Re: Application for Site Plan Review and Special Permit  
102 Howe Street, Ashland Landfill  
Response to Peer Review Comments

AMEC Massachusetts, Inc. (AMEC) is pleased to provide the following responses to comments received from the Town of Ashland's consultant, GCG Associates (GCG), in a letter dated February 8, 2016. GCG's comments are included for reference and AMEC's responses follow each comment.

## ASHLAND LANDFILL 907 KW SOLAR PV DEVELOPMENT ASHLAND, MASSACHUSETTS JANUARY, 2016 ISSUED FOR SITE PLAN REVIEW REVISED FEBRUARY, 2016

DESIGNED BY: AML  
CHECKED BY: REW  
PROJECT NUMBER: 200909001B-002  
DRAWING NUMBER: L-501  
SHEET NUMBER: 6 OF 8

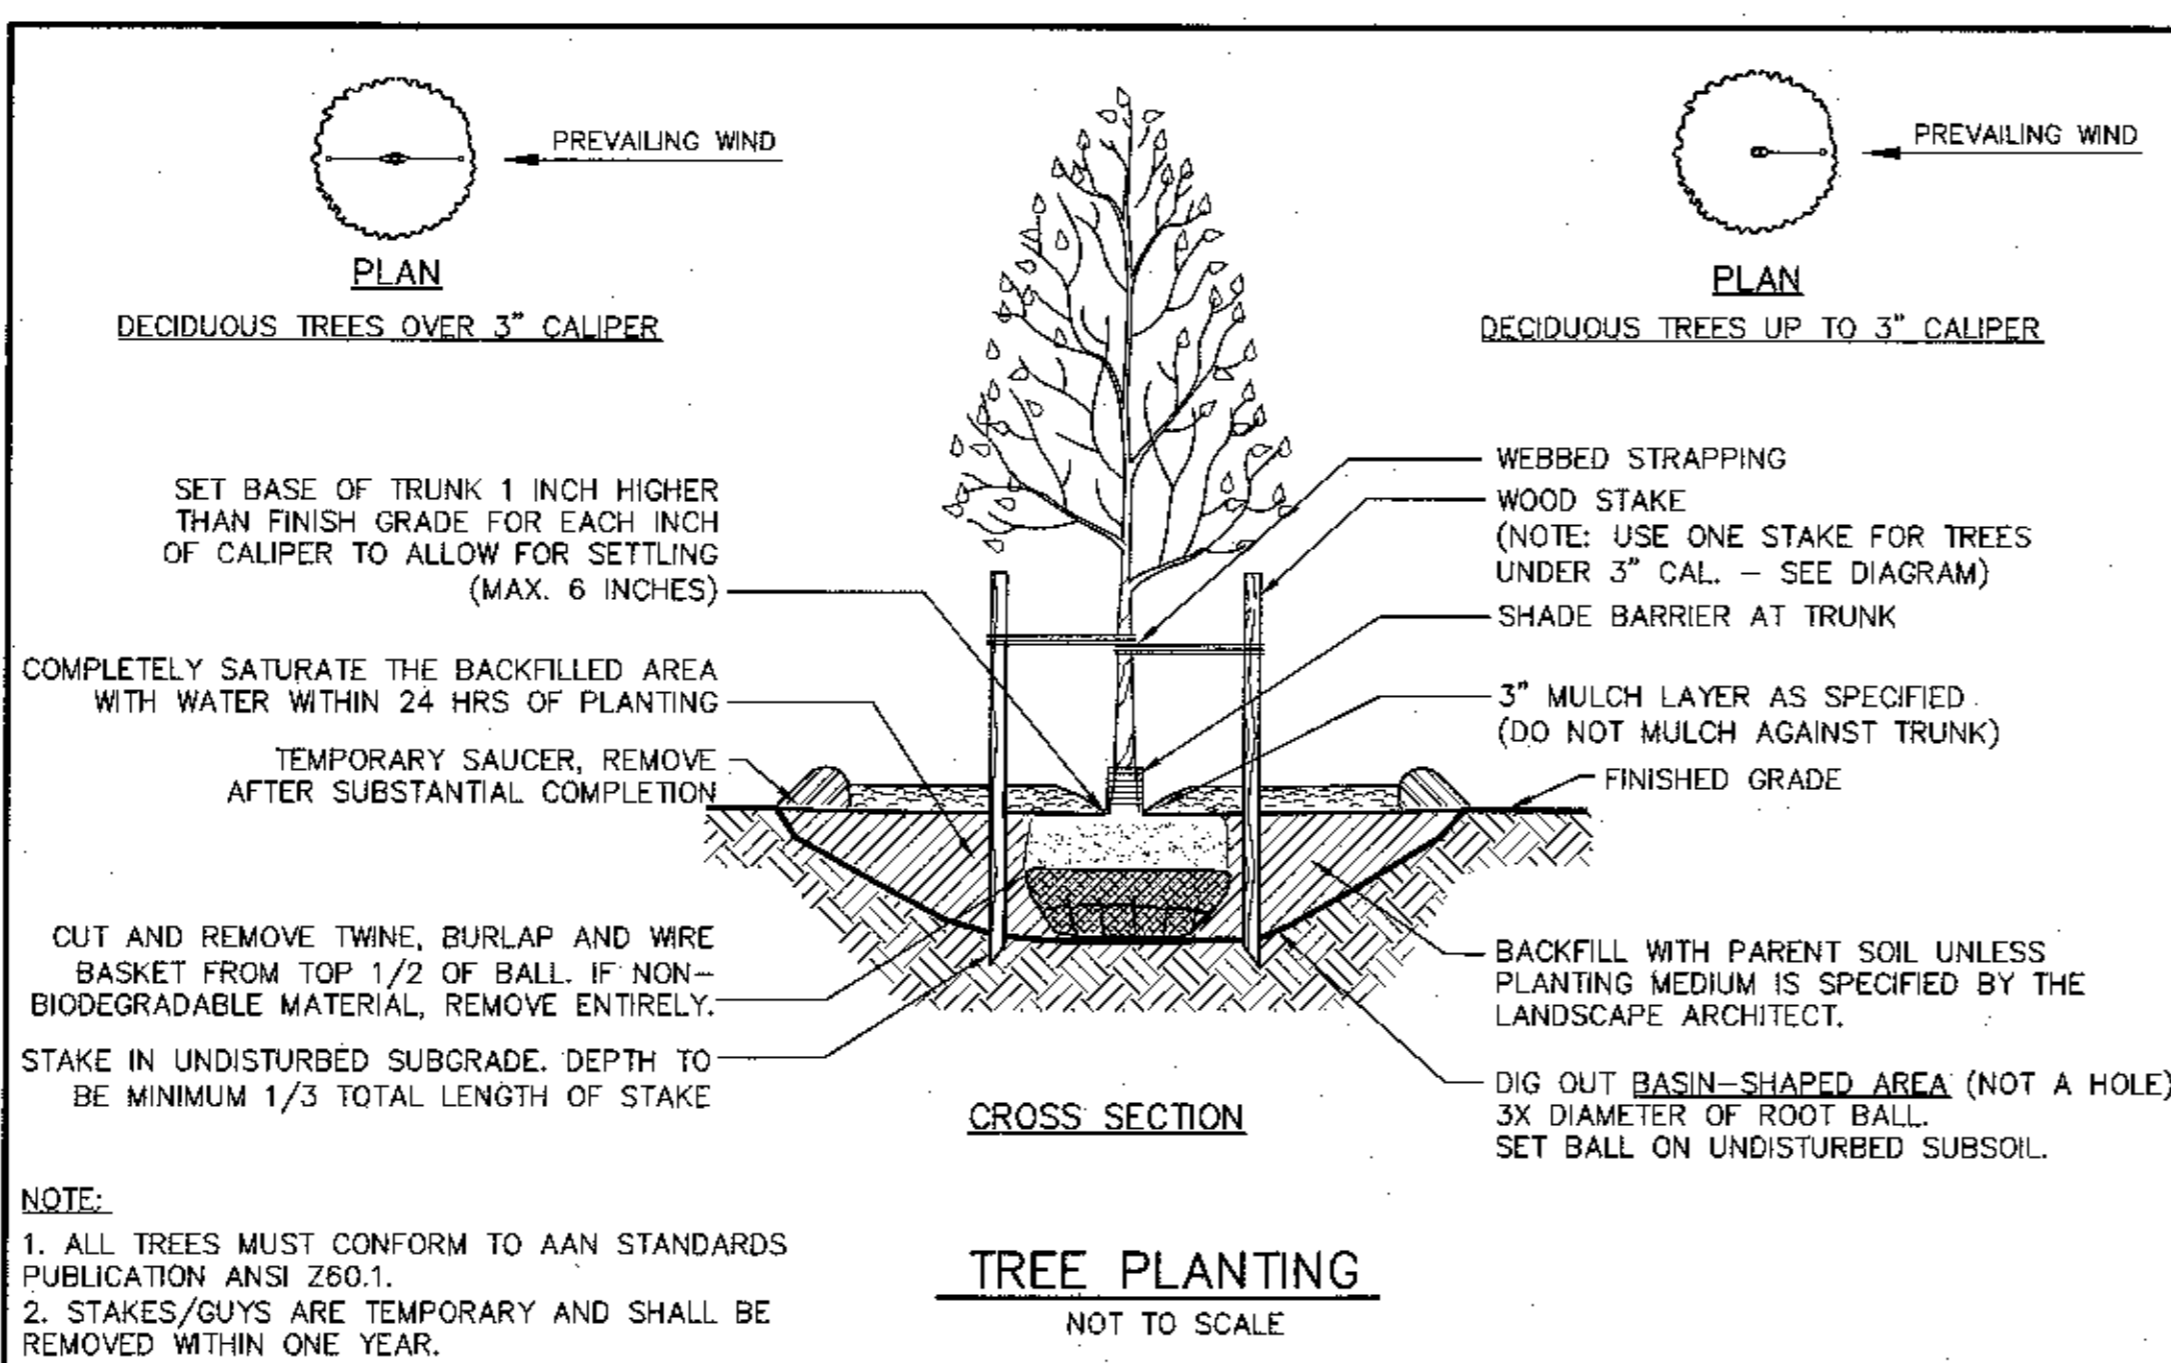
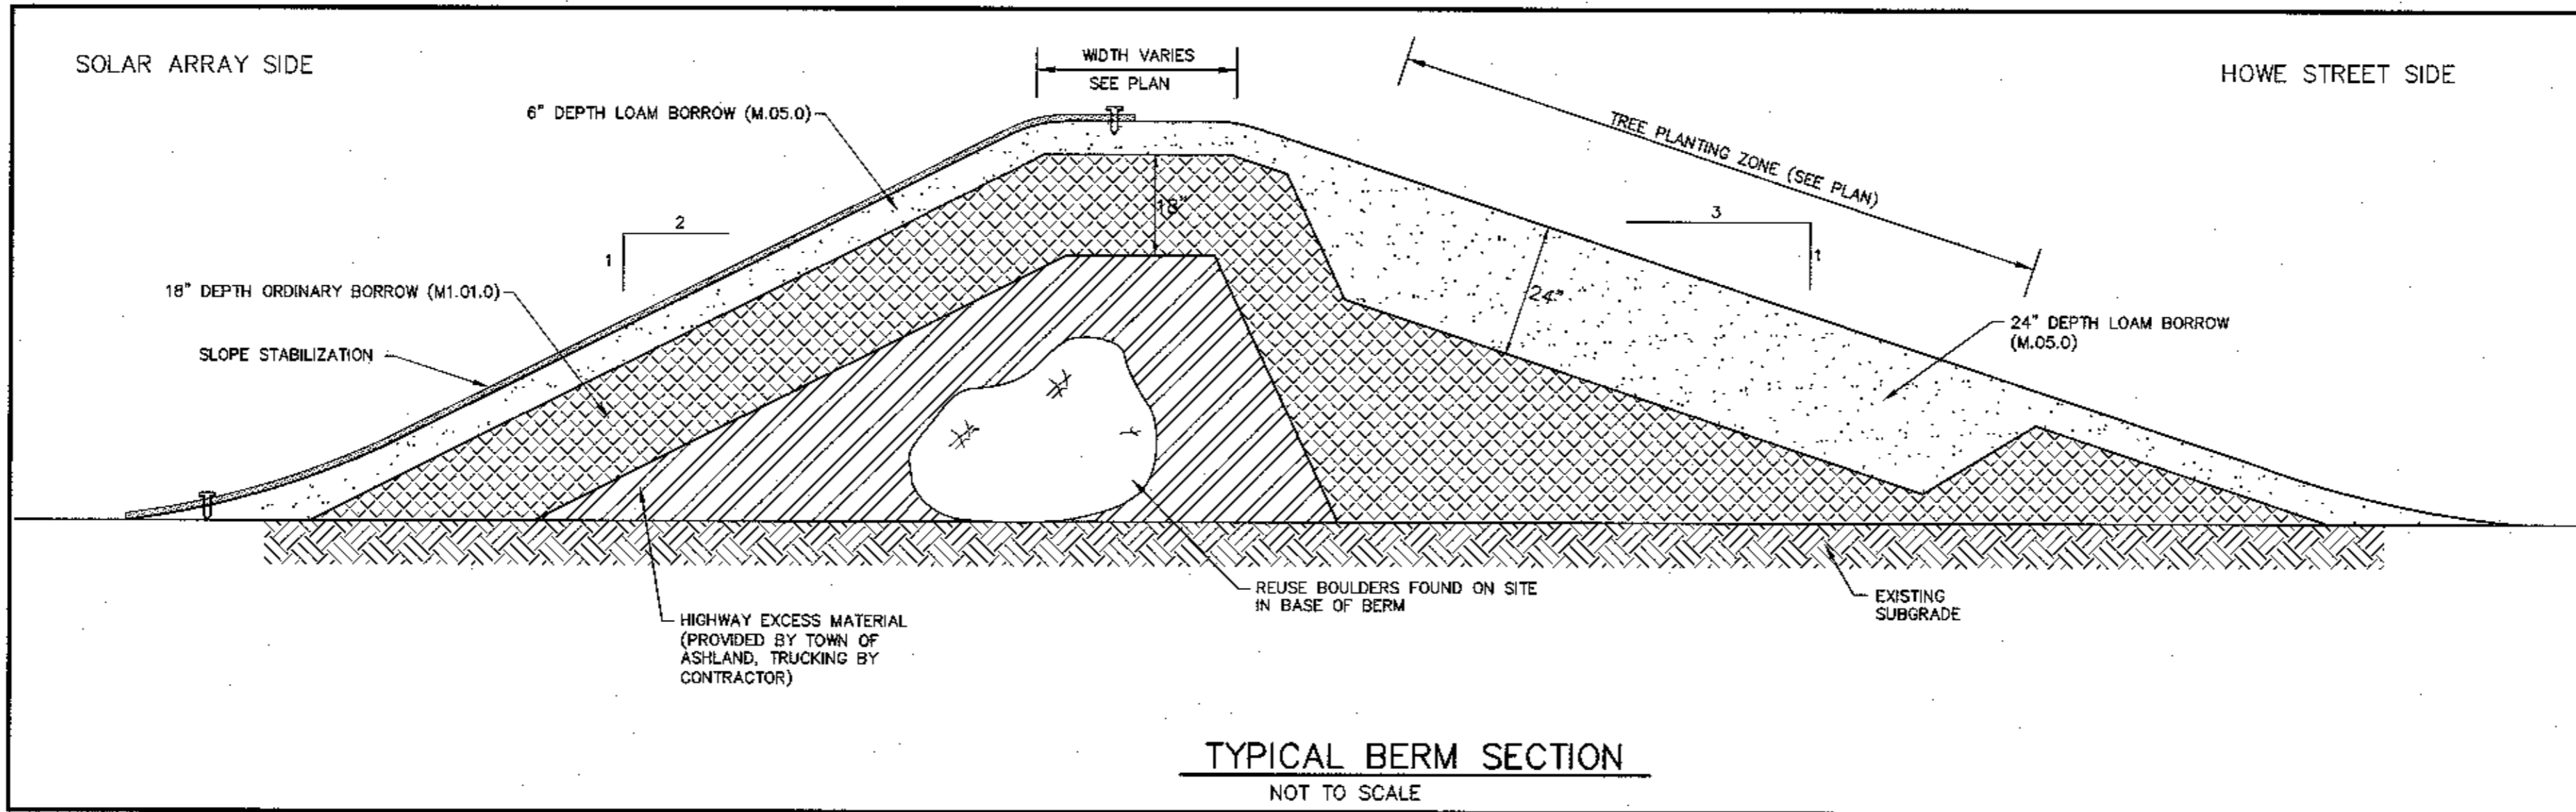
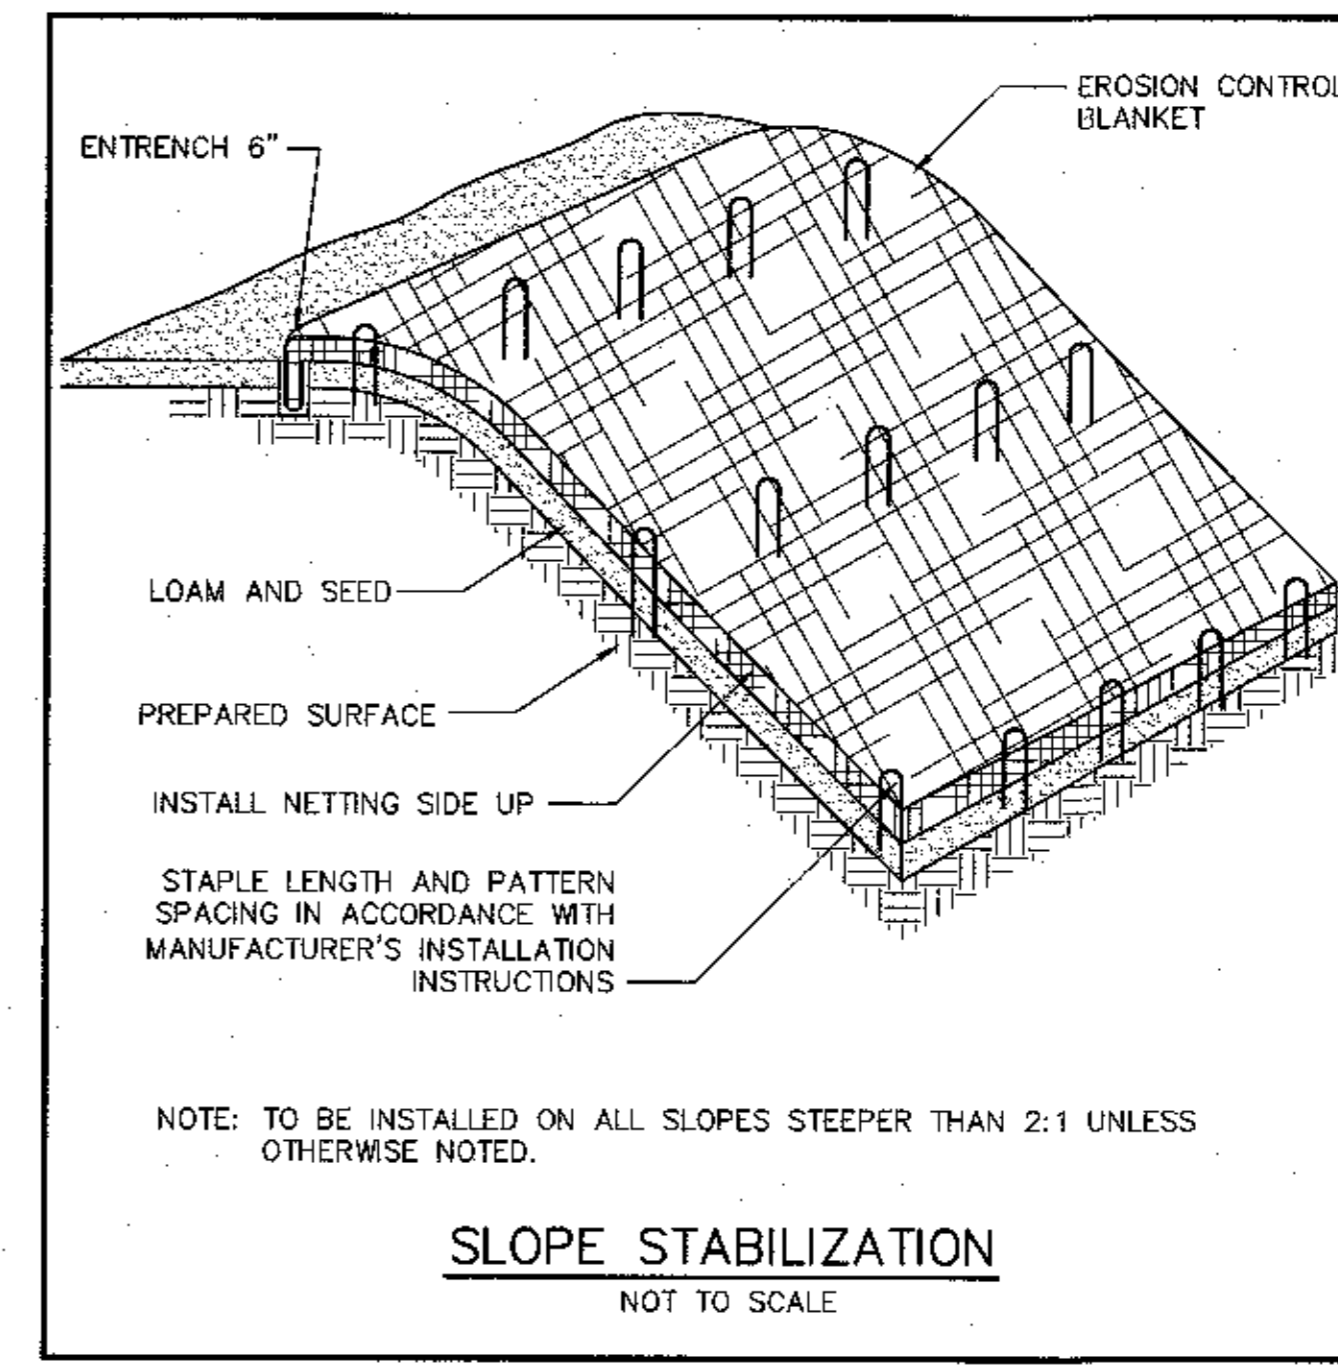
1. Typical Berm Section would require erosion control blanket protection over the 2 horizontal to 1 vertical slope face of the berm. The blanket detail was mentioned on plan sheet 1, but not included on the plan set.

**Engineer's response:** The erosion control blanket detail and notes have been added to Sheet 4. Erosion control blanket is required on all slopes greater than 3:1, therefore it will be installed on the 2:1 slope on the solar array side of the berm. The typical berm section detail on Sheet 6 has also been revised.
